# NEWMAR CORPORATION WARRANTY DEPARTMENT

TECHNICAL SERVICE BULLETIN						
DATE ISSUED	MODEL YEAR(S) AFFECTED		MODEL(S) AFFECTED		TSB#	
3/9/94 1993-1994			All		90	
BRAND			Түре			
All Americ	can Star 🛭 Kountry Star 🗷	Du	tch Star 🛚	All 🗖 T	T□ FW□	
NewAire □ Mountain Aire ■ Kountry Aire ■			ndon Aire□	C A ■ D	PD DBD	
☐ Air Conditioning & Heating			☐ Electrical Components			
☐ Appliances & Accessories			☐ Exterior Components			
☐ Cabinets & Furniture			☐ Interior Components			
☐ Chassis Components			☐ Plumbing & Bath Components			
■ Construction Components			☐ Windows, Awnings, Vents, & Doors			
DESCRIPTION OF PROBLEM  Batteries going dead on Class A motorhomes when unit is being stored.						
RECOMMENDED SOLUTION  Add relay per attached print and instructions. Relay may be purchased in the Newmar Parts Department. If						
	please contact a Newmar Servi			e Newmar Parts	Department. If

#### CORRECTION FOR GRANNING TAG AXLE UNITS

The following instructions are for a Potter Brumfield relay # VF4-15F11

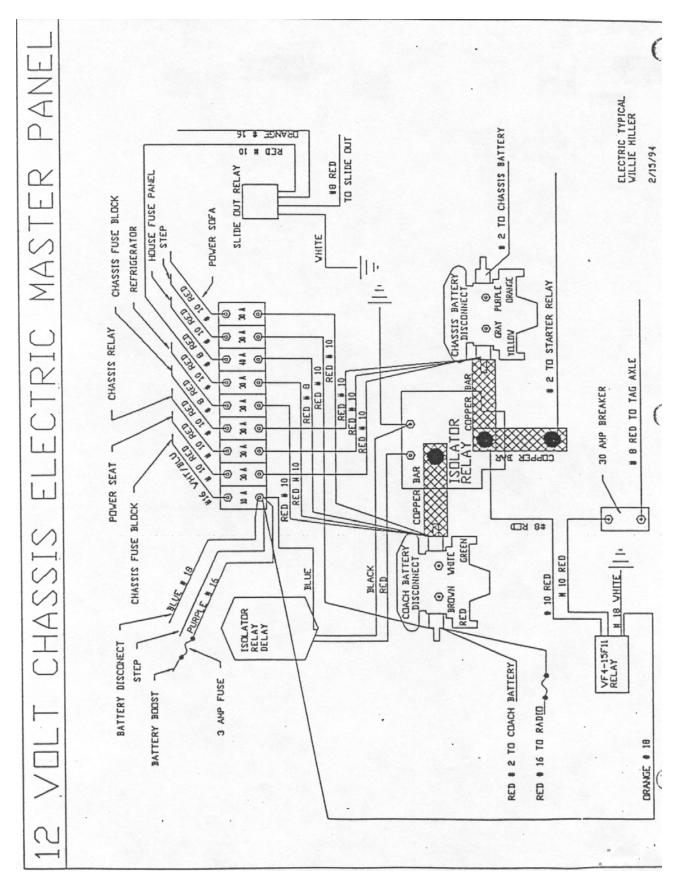
Recently several persons have had problems with the battery discharging while the unit is not in use and the temperature is below 40 degrees. The reason for the discharge is a moisture dryer that is in the compressor tank in the Granning air suspension system. The dryer is thermostatically activated at about 40 degrees. This dryer was accidently hooked up to a constant hot terminal instead of an ignition hot. Please follow these instructions to make the necessary correction to your unit. The correction will install an ignition activated relay between the power source and the dryer.

- 1. Remove the clear plastic cover on the 12 volt junction box in the front compartment of the motor home.
- 2. Disconnect the #8 red wire that feeds the tag axle components from the terminal post on the mini breaker.
- 3. Connect one of the red wires from the relay to the terminal that the #8 wire in step one was connected to.
- 4. Connect the other red wire from the relay to the #8 red wire that feeds the tag axle components. (the wire removed from the terminal in step one)
- 5. Attach the white wire from the relay to a solid ground to the chassis.
- 6. Attach the orange wire to the ignition hot breaker in the junction box.
- 7. Reattach the plastic cover to the 12 volt junction box.

The dryer will now receive power only when the ignition is in the on position.

CAUTION: DO NOT REWIRE THE SYSTEM BY A METHOD THAT WILL ALLOW THE DRYER TO FUNCTION ONLY WHEN THE AIR COMPRESSOR IS WORKING. THIS COULD CAUSE SERIOUS DAMAGE TO YOUR VEHICLE.
